Subject: Almond 2 Power Plant (09-AFC-02)
CURE Data Responses Set 1A

Almond 2 Power Plant

(09-AFC-02)

CURE Data Responses, Set 1

FIGURE 5.1.13
CO₂ Emissions from Peaking Power Plants in California

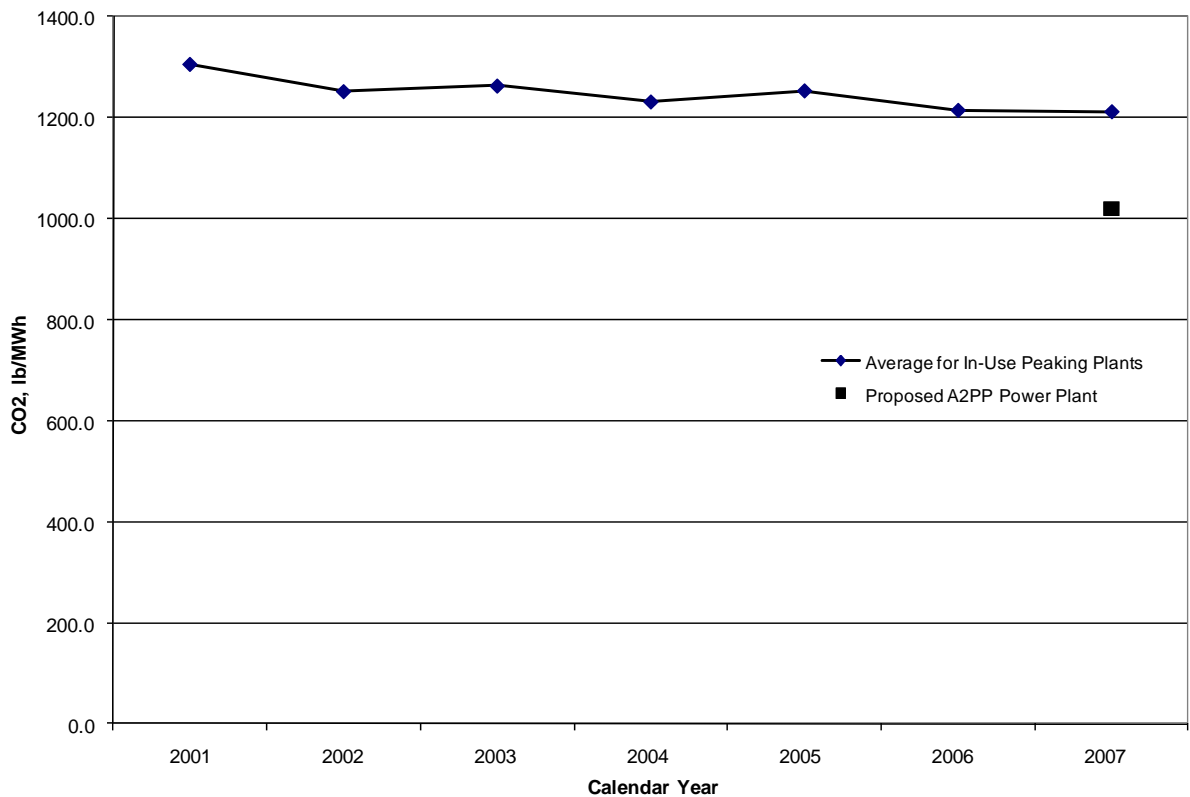
- CURE-1. Please provide the following data regarding GHG emissions after A2PP begins commercial operation:
- a. The annual expected GHG emissions from A2PP.
 - b. The change in GHG emissions from TID-dispatched facilities due to the addition of A2PP to the TID system.
 - c. The change in GHG emissions from non-TID generators (if any) due to the addition of A2PP to the TID system.
 - d. Please explain how TID dispatches its system (e.g., cost-minimization, emissions minimization, fuel-use minimization, other) and how TID decides between operation of TID-controlled facilities and purchases from non-TID sources.
 - e. Please provide the expected quantity (in gwh/year) of annual purchases and sales of energy by TID from non-TID sources, with and without A2PP.

The A2PP will not increase the overall system heat rate for natural gas plants.

A2PP will be operated as a peaking plant, not a baseload plant, and as such its heat rate and resulting GHG emissions must be compared to other facilities serving a similar role. In the AFC,² TID compared the projected CO₂ emission rate from A2PP with the CO₂ emission rate from other, comparable projects. As stated in the Avenal PMPD, "...heat rate is directly correlated with emissions (including GHG emissions)..." [p. 104], so lower CO₂ emissions on a lb/MWh basis correspond to a lower heat rate. Figure 5.1-13 of the AFC, reproduced below, showed that CO₂ emissions in lb/MWh will be much lower from the A2PP than the emissions from existing peaking turbines in California. The project would not increase the overall system heat rate for natural gas plants because it has a lower heat rate than, and would operate to replace energy from, existing, less efficient peaking power sources in the service territory. In the event that the demand for electricity does not reach plants with efficiencies comparable to that of A2PP, only plants more efficient than A2PP will operate. In that case, A2PP will not run and will not emit any GHGs.

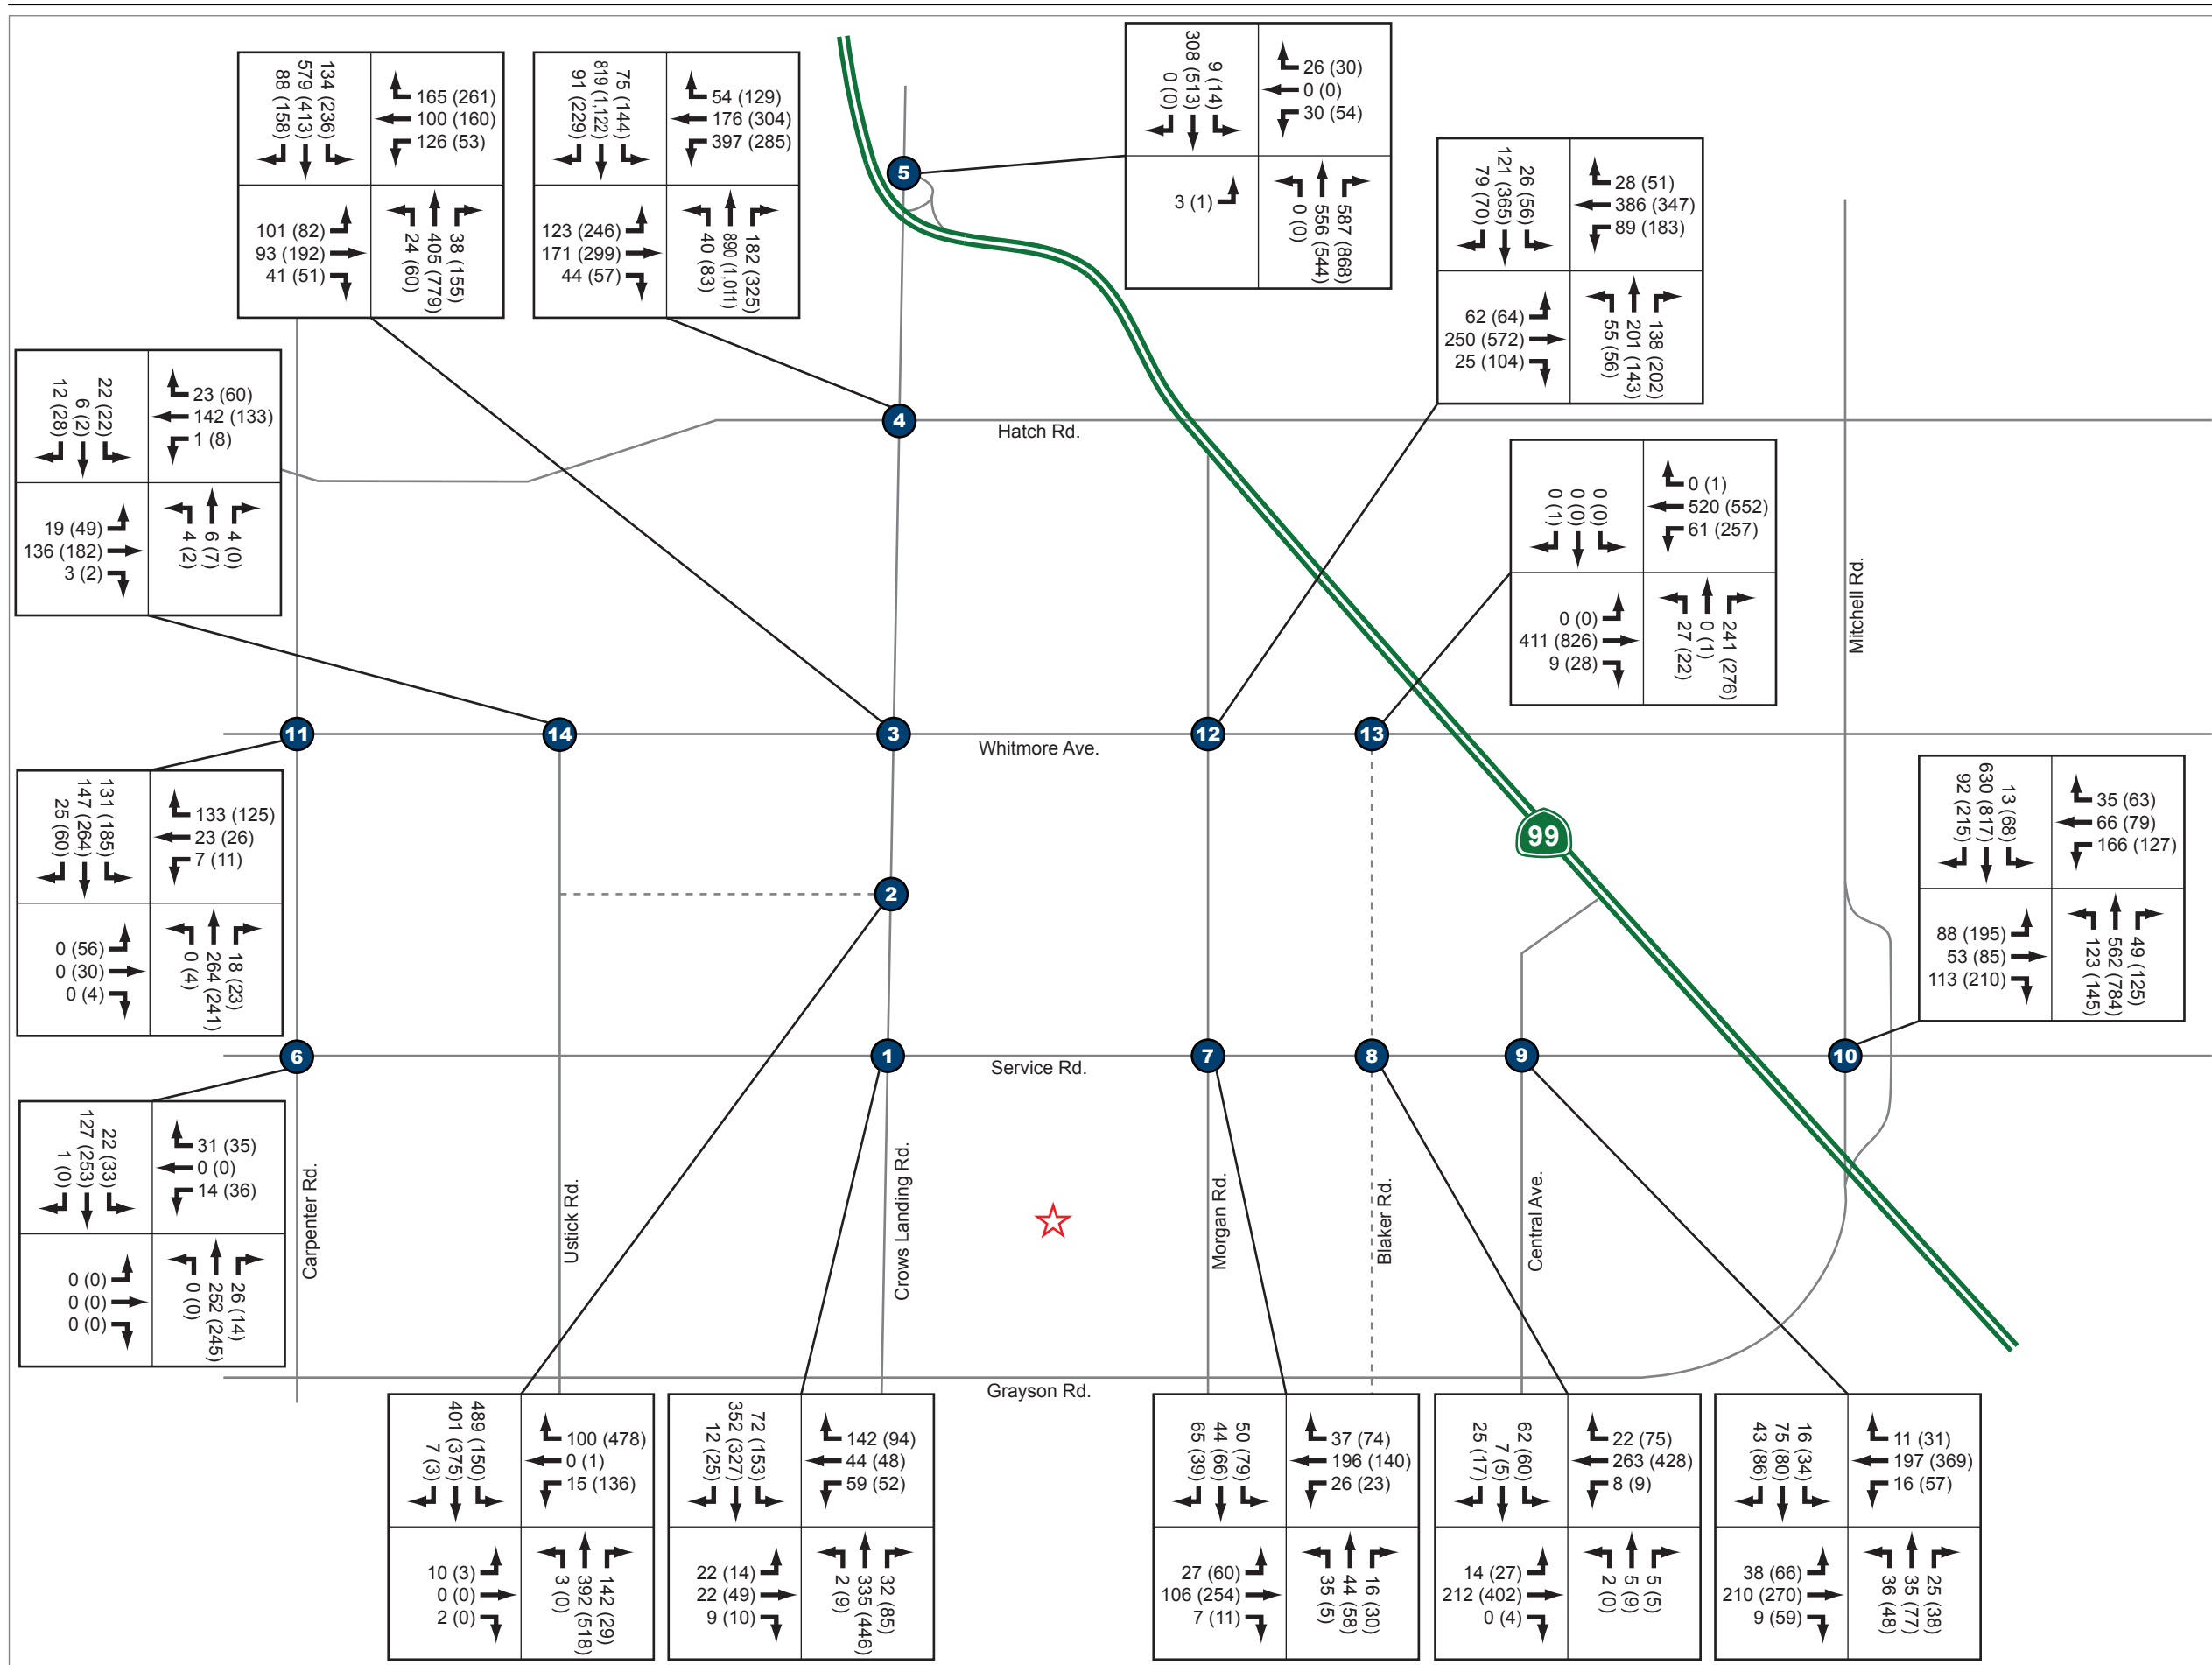
CURE-105. Please disclose, analyze, and mitigate any potentially significant impacts to traffic at the proposed vehicle access point connecting to Morgan Road during construction.

Response: No site access point connecting to Morgan Road is planned. Therefore, no impact is expected to occur on Morgan Road from construction traffic.
